## **Appendix A – PPC17 Addendum (Transportation Review)**

# Memo

**Subject:** Private Plan Change 17 – Te Rapa North Industrial – Addendum Technical Specialist Memorandum

**Technical Area:** Transportation

Figure 1: Te Awa Lakes Structure Plan

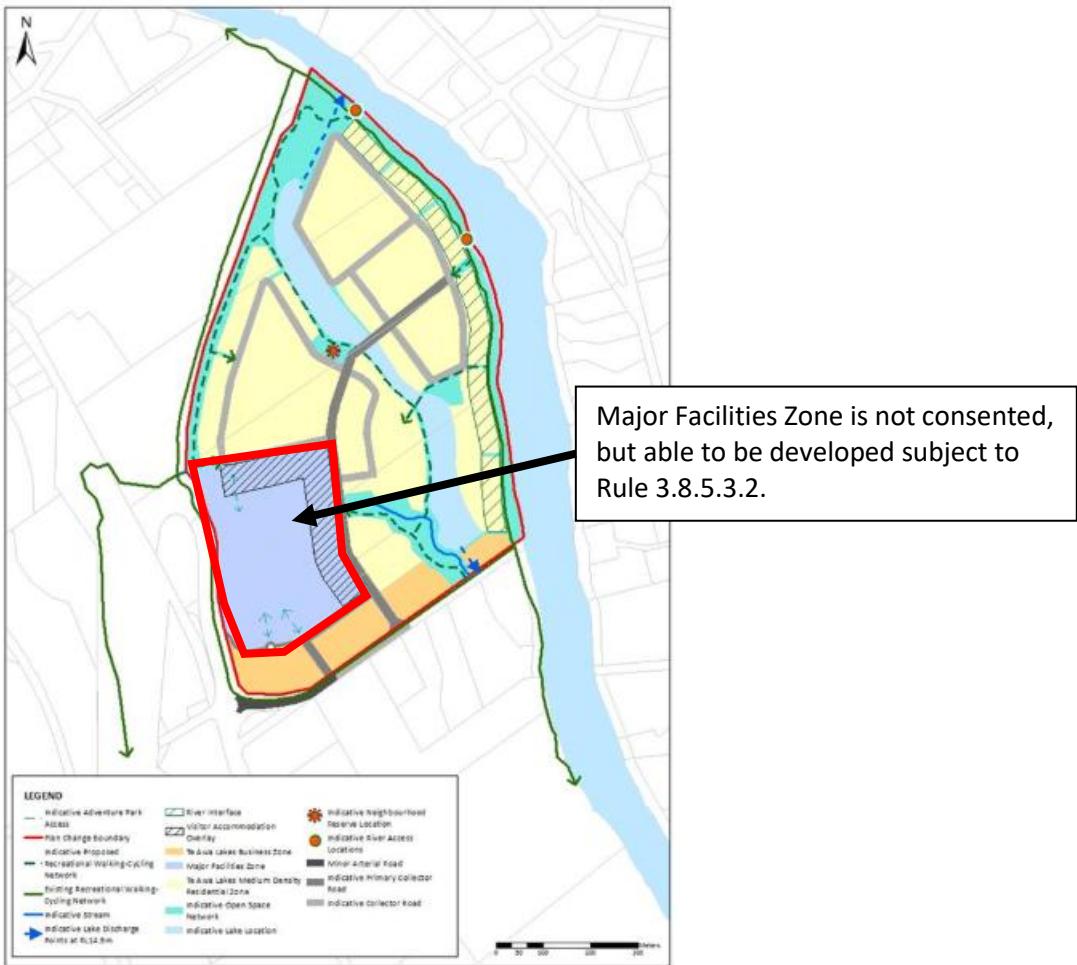
13. I am concerned that the underlying land use and trip generation that forms the basis for the PPC17 has been reduced to reflect consented traffic limits from the TAL area rather than the land use and trip generation permitted by the TAL Structure Plan and projected in the WRTM.

16. Mr Inder<sup>7</sup> does not consider the Major Facilities Zone to form part of the future transport environment. Mr Inder's assessment<sup>8</sup> has adjusted the WRTM baseline by reducing peak period trips from Te Awa Lakes area to match the consented<sup>9</sup> trip generation limits of:

17. This is significantly less traffic than the WRTM predicts for the full development of the TAL Structure Plan. The table below shows the TAL traffic in the 2035 scenario that supported the Request (highlighted blue) and the significant reduction in TAL traffic in the recent transport modelling scenarios that Mr Inder's evidence relies on.

Figure 3 Proposed Structure Plan<sup>28</sup>

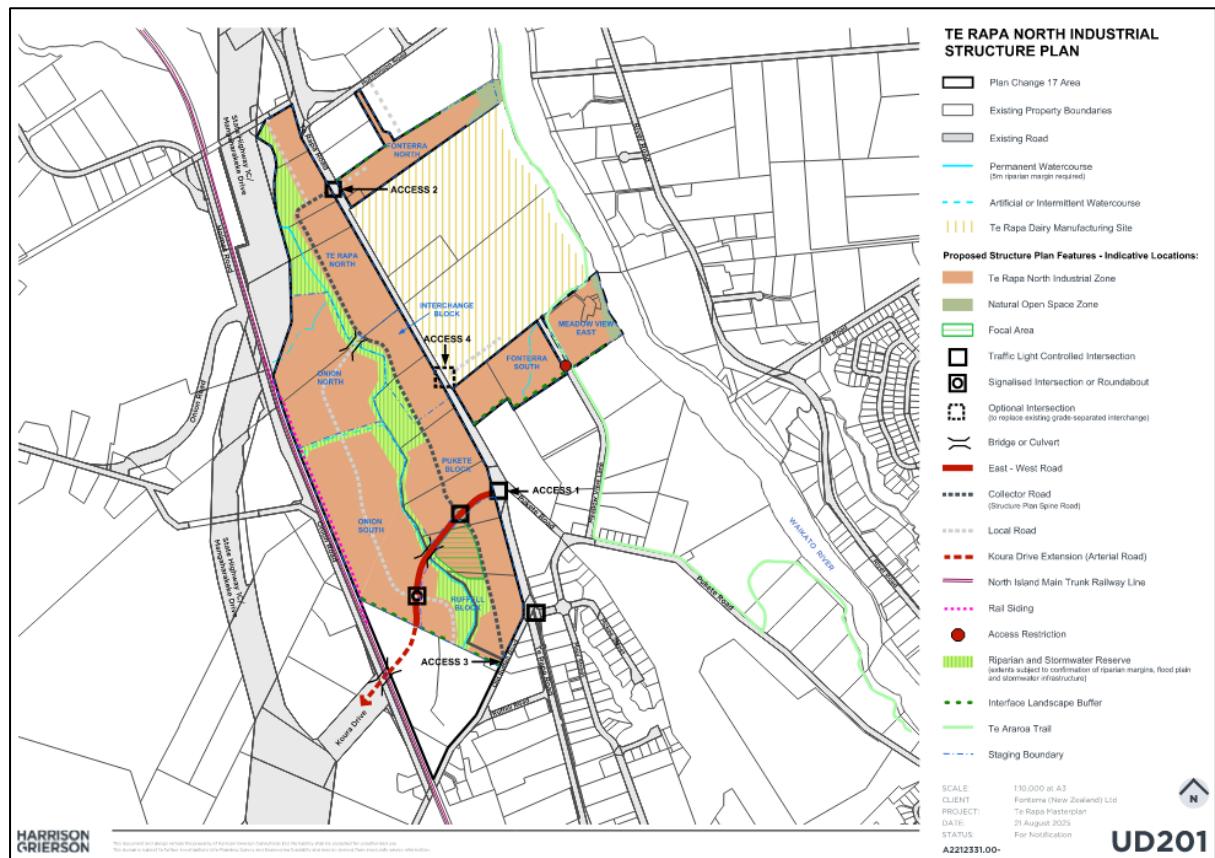
44. I am concerned that there is no updated Structure Plan map that illustrates the infrastructure staging and development areas that are set out in Table 3.9.3.2a. Without an updated Structure Plan map and Transport Infrastructure Plan it is not clear where development will occur and where infrastructure improvements are required.

45. I note that there are inconsistent references to accesses and land development blocks within Mr Inder's evidence and within the proposed provisions. For example, access to the initial development is from the south via Old Ruffell Road. This access is labelled "Access 3" on the Proposed Structure Plan, however Mr Inder<sup>26</sup> refers to this as "Access 1".

47. I consider that walking and cycling connections and bus stops should be shown on the Structure Plan map.
48. The Fonterra Evidence (Mr Inder and Mr Grala<sup>27</sup>) both include the figure below showing three development areas of the PPC17. These development areas and naming are inconsistent with the proposed structure plan.

Figure 4: Recommended PPC17 Transport Infrastructure Plan

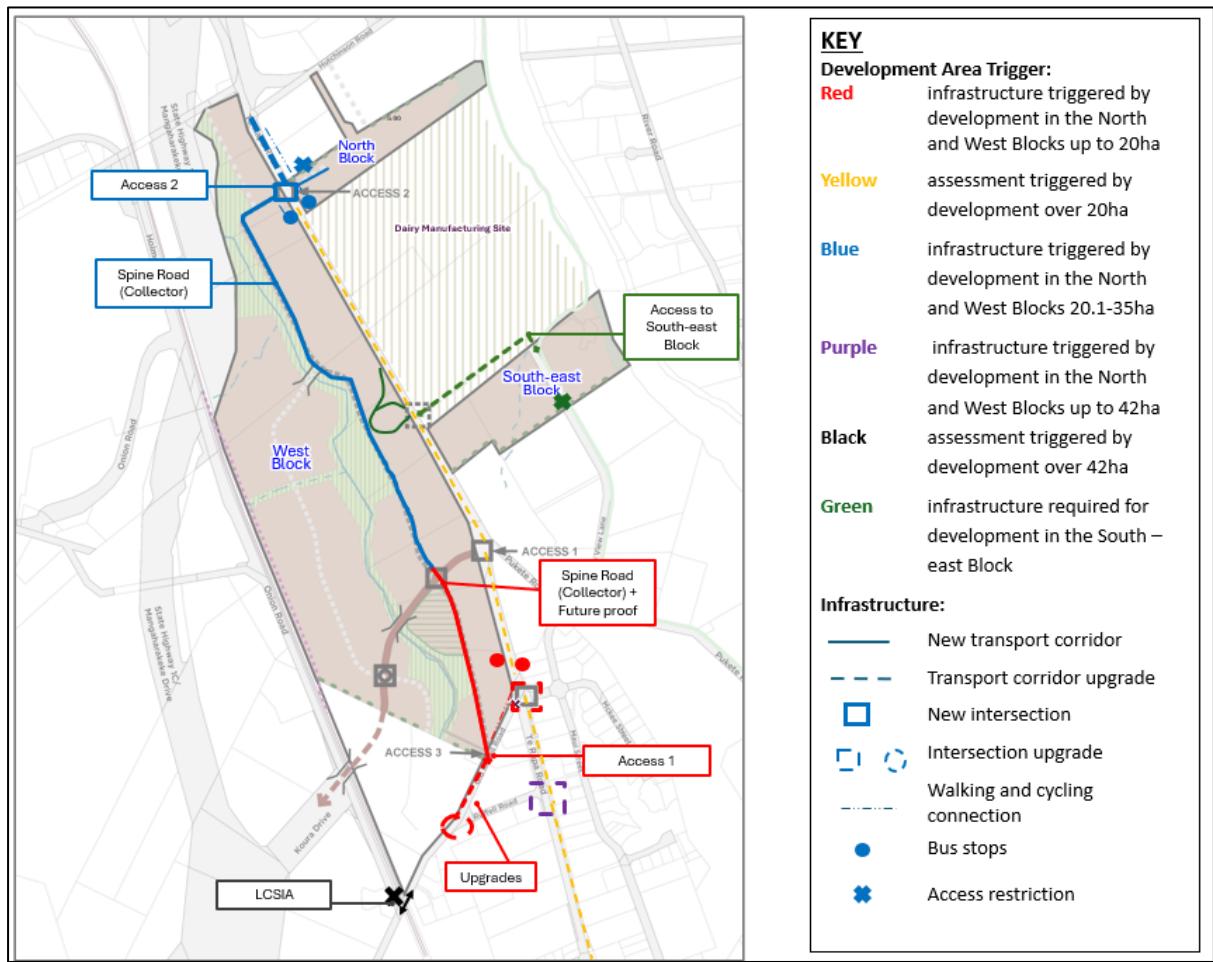
50. Figure 4 below illustrates my recommended Transport Infrastructure Plan with the development areas and naming consistent with Mr Inder's Figure 2. In the paragraphs below I provide my reasons and recommendations for the amendments to the planning provisions.

67. I consider that the bus stops and the walking and cycling connection should be shown on both the Structure Plan and the Transport Infrastructure Plan (as indicated on Figure 4 above).

*Figure 5: Existing Od Ruffell Road/Ruffell Road Give Way priority T-intersection*

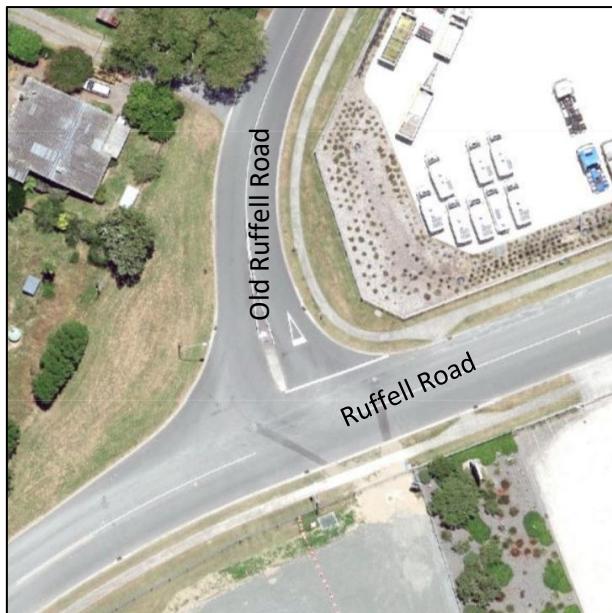
52. The existing intersection is a Give Way priority T intersection. There is no marked right turn bay on Ruffell Road and Old Ruffell Road is on a skew angle. There is a risk that large vehicles generated by the PPC17 turning between Ruffell Road and Old Ruffell Road (left

turn out and right turn in) will not be able to make the left turn out without crossing the centreline and present a safety risk to other road users.

53. PPC17 has not provided a safety assessment of the existing intersection or assessed the impact of additional traffic including a high proportion of heavy vehicles using the intersection. In my view there will be a significant change in the intensity, nature of vehicles and turning demand at the intersection. Vehicle tracking has not been provided to confirm that the existing arrangement is adequate to accommodate the additional PPC17 traffic and heavy vehicles associated with industrial traffic. This will be the only access to the initial 20ha of development which is expected to generate 325 vph. I am concerned that this is significant change in traffic volumes and turning demand will lead to an increase in crashes.

- *Design and construction of the Old Ruffell Road/ Ruffell Road intersection upgrade to a roundabout.*
- *The roundabout be completed prior to:*
  - i. *Any section 224c certificate for subdivision under the Resource Management Act 1991 ('RMA') being issued that takes the cumulative net developable area in the West Block of the Structure Plan up to and including 20ha: or,*
  - ii. *Any industrial / commercial activity within the West Block of the Structure Plan area generating a cumulative average weekday pm peak traffic volume up to 325 vehicles per hour (two-way), accessing via Old Ruffell Road*

Figure 6: Safe System Assessment

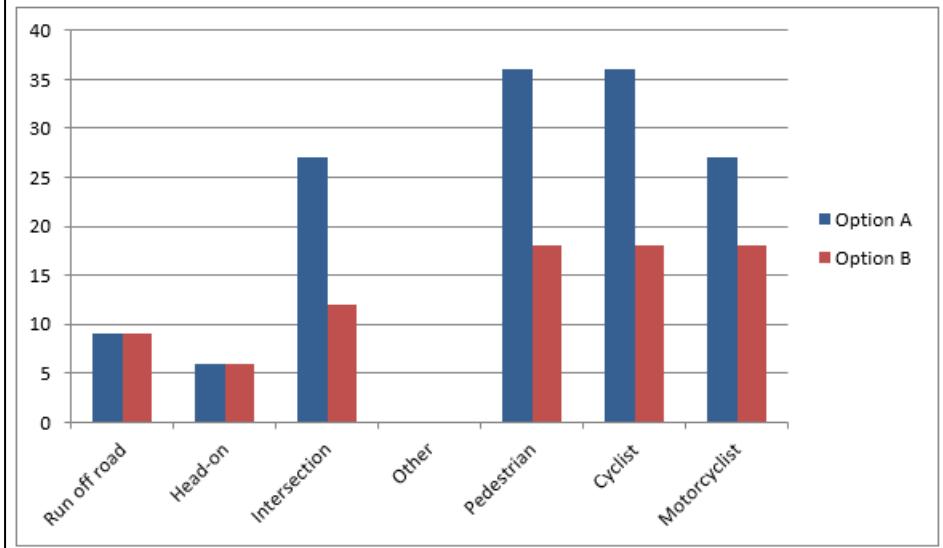
54. Roundabouts are inherently safer than priority T- intersections because they better manage vehicle speeds and reduce conflict points and crash severity. I have instructed that a safe system assessment be prepared in accordance with the NZTA Safe System Audit Guidelines for transport projects<sup>29</sup> to compare the existing intersection and a roundabout. The assessment is based on the increased traffic movements expected to be generated by 20ha of development. The Safe System Assessment score for the roundabout is 81/448 compared to 141/448 for the T intersection, confirming that a roundabout is a safer form of intersection to facilitate the increase in traffic movements from PPC17.

55. In my view, a roundabout is needed to safely accommodate the increase in traffic generated by PPC17 and will provide a safer form of intersection, manage vehicle speeds, and provide for all movements. It will also future proof the intersection so that it could safely accommodate any other changes in traffic such, for example, if the Ruffell Road level crossing is opened or additional industrial development is enabled.

Figure 7: Old Ruffell Road/Ruffell Road roundabout concept

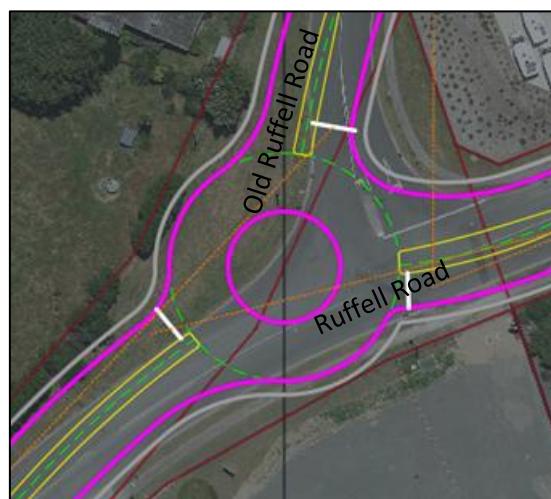
56. I instructed that the roundabout concept shown below be prepared. This concept demonstrates that a roundabout with an 8m diameter central island will fit within the existing road reserve. The design vehicle used for the concept design is the 17.9m semi-trailer demonstrating suitability to accommodate industrial traffic.

*Figure 8: Recommended Spine Road connection to Old Ruffell Road<sup>30</sup>*

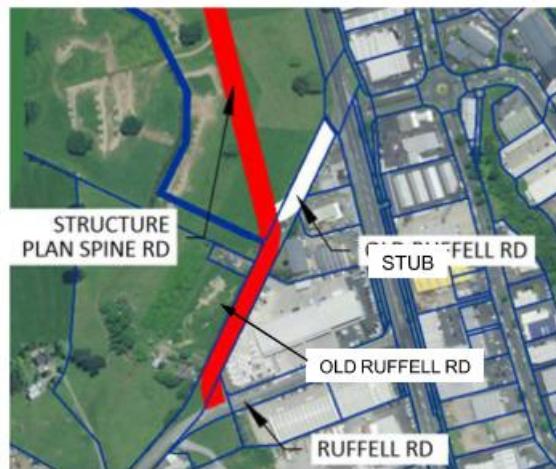
58. The Structure Plan Spine Road is proposed as a continuous north south collector road including:

- a. A connection to Old Ruffell Road;
- b. A T-intersection with Old Ruffell Road stub; and
- c. Future proofing for a four-leg intersection between the Spine Road and the planned Northern River Crossing.

59. PPC17 does not include a concept layout for the Spine Road connection to Old Ruffell Road or the T- intersection for the stub. There are existing industrial businesses along Old Ruffell Road and the design of the Spine Road will need to maintain access to the existing businesses, provide appropriate separation distances and vehicle tracking.

60. The proposed provision (Rule 3.9.3.2a) requires future proofing for a four-leg intersection between the Spine Road and the planned NRC. In my view this will require development of a concept design at the time of subdivision to demonstrate that the intersection meets the

Figure 9: Recommended cross -section for Old Ruffell Road upgrade to collector (Figure 3.9.2.5.e)

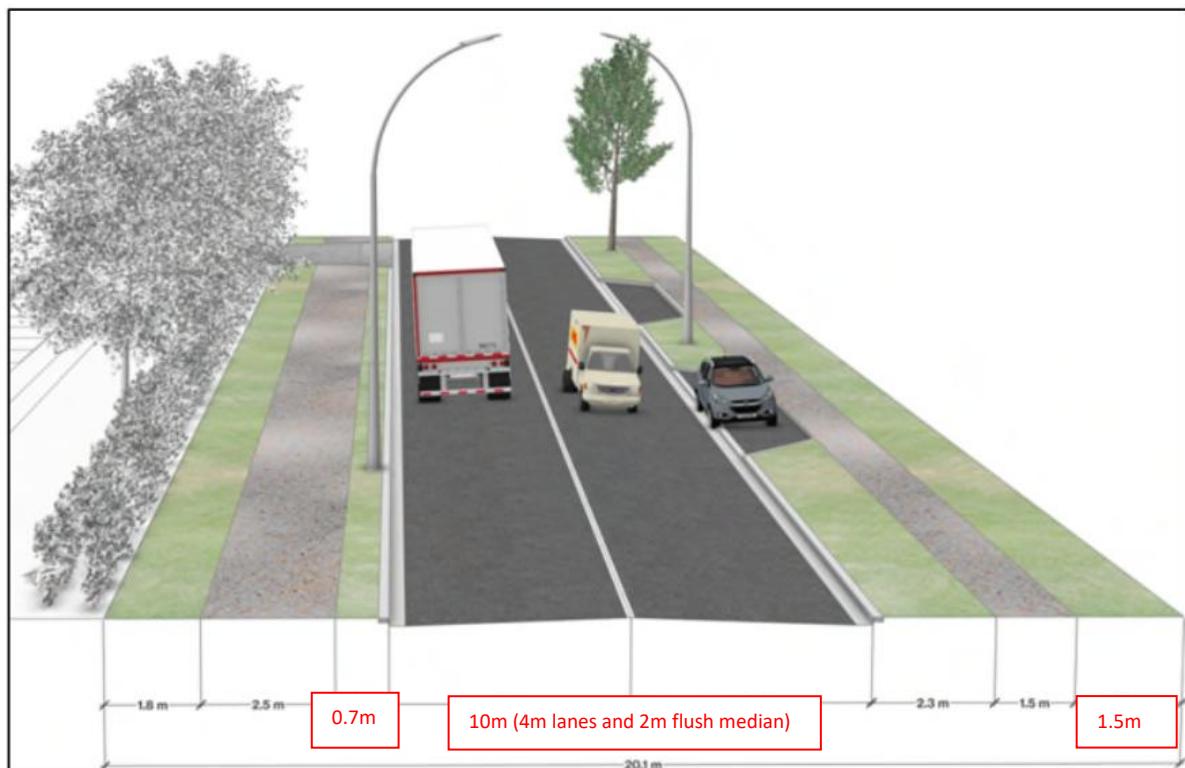
62. I agree that Old Ruffell Road needs to be upgraded to collector cross-section. However, the existing road reserve is around 20m wide and the District Plan<sup>31</sup> cross section for an industrial collector road is 26.5m wide and cannot be provided within the existing road reserve.
63. I support the proposed modification to the footpath/ shared path. However, I recommend that the carriageway should provide two 4m wide traffic lanes and a 2m flush median. I recommend that Figure 3.9.2.5e is updated as shown below. Providing a flush median will provide space for vehicles to turn at the existing industrial vehicle crossings and is consistent with the proposed Structure Plan Spine Road (Collector).

*"Upgrade of Old Ruffell Road to Collector standard in accordance with the typical cross-section shown in Figure 3.9.2.5.e between the Structure Plan Spine Road and Ruffell Road. The upgrade shall include provision for a walking and cycling connection between the Structure Plan spine Road and the existing bus stops north of McKee Street on both sides of Te Rapa Road."*

Figure 10: LHS- aerial photograph of the interchange. RHS – indicates the interchange and conflict with the Structure Plan Spine Road

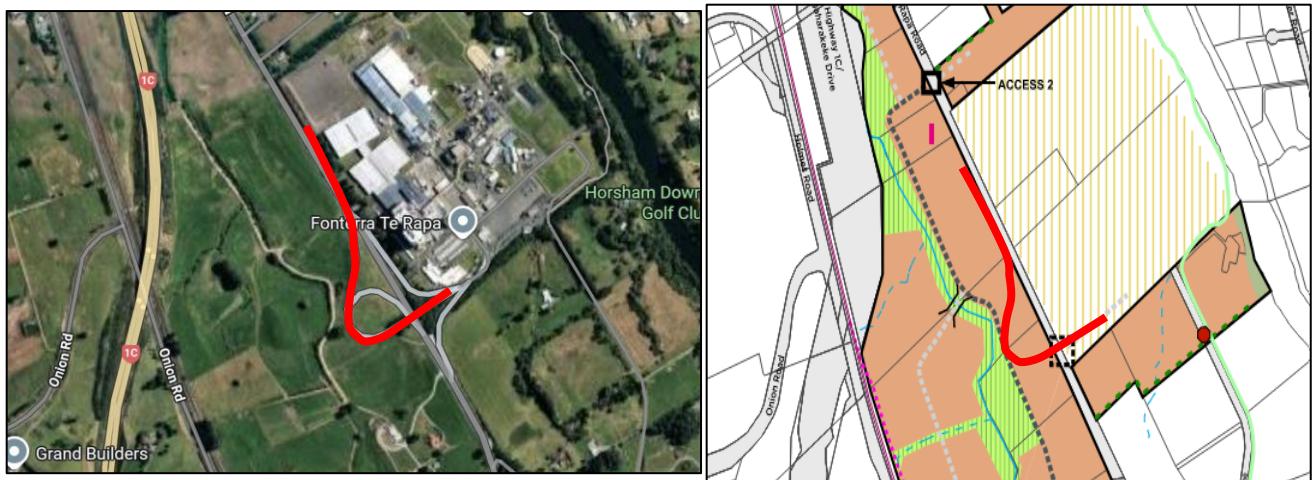
78. The Request included an optional at-grade intersection to replace the Dairy Factory interchange on Te Rapa Road. However, this is not required through the proposed provisions. The location of the Spine Road as indicated on the Structure Plan appears to conflict with the Dairy Factory interchange. This is annotated in Figure 10 below.

79. In my view, detailed design of the Spine Road will need to consider the existing features including the interchange and the riparian and stormwater reserve. This is a risk that the detailed design may identify that changes to the location and alignment of the Spine Road and/or the interchange may be required. It is possible that an additional structure may be needed to cross the stream.

Figure 11: Property map in South-East Block

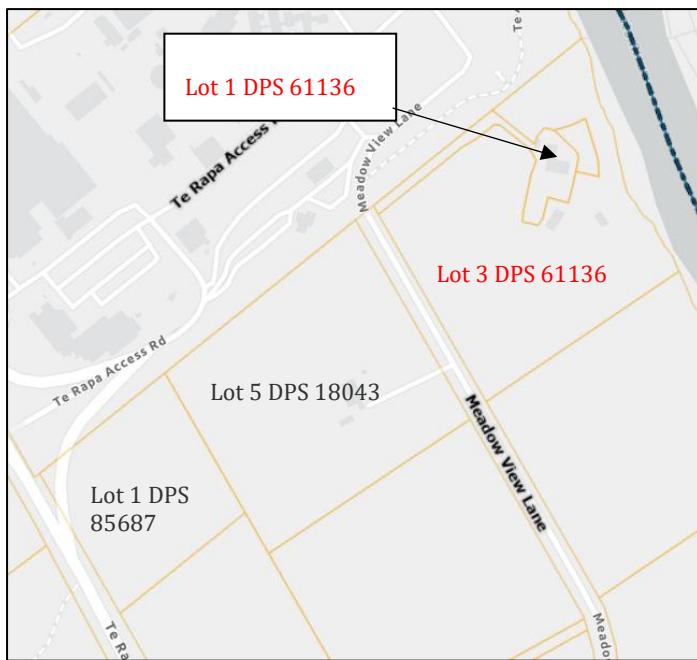
82. The Structure Plan indicates a local road and the optional at-grade intersection to replace the existing grade-separated interchange. The local road (grey dashed line) is shown through the Dairy Manufacturing site. It is not clear if this is to be a public road, private road or some form of easement. I am concerned that the sites in the South-East block may not have access to a public road.

83. Rule 12.5.1a includes a Vehicle Access Restriction. It is not clear to me if the proposed Rule is sufficient to ensure access is provided to the two properties as they do not have access to a legal road. It is also not clear how Lot 1 DPS 61136 or Lot 3 DPS 61136 will be provided vehicle access. In my view, further legal and planning advice is required to ensure that this rule is acceptable.

84. I recommend that the Rule 12.5.1a is amended to include the two missing lots:

Figure 12: Porters' land on the eastern side of the NIMT and suggested local road

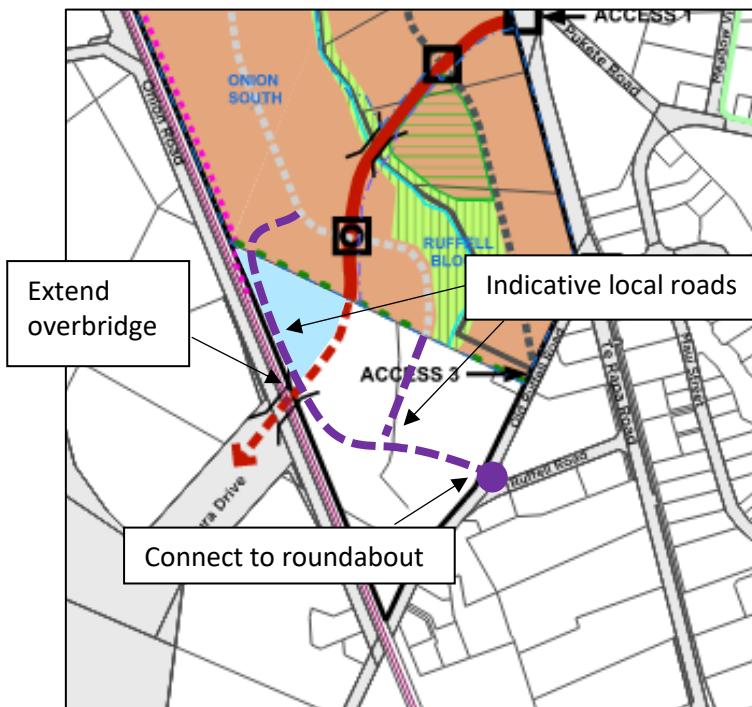
119. I agree with Mr Inder<sup>54</sup> that direct access to the balance of Porters land on the east side of the railway should be to Ruffell Road (rather than to the East-West Road). A fourth leg at the Old Ruffell Road/Ruffell Road intersection would be an appropriate way to provide for this access into the Porters' land.

121. I partly disagree with Mr Inder as the overbridge and embankment will sever the Porters' land. This severance could be minimised by lengthening the overbridge to provide a local road parallel to the NIMT maintaining connectivity within the Porters land. If the Panel were supportive of including the Porters' land in PPC17, I recommend that this north-south local road be shown parallel to the NIMT to provide connectivity within the Porters' land.
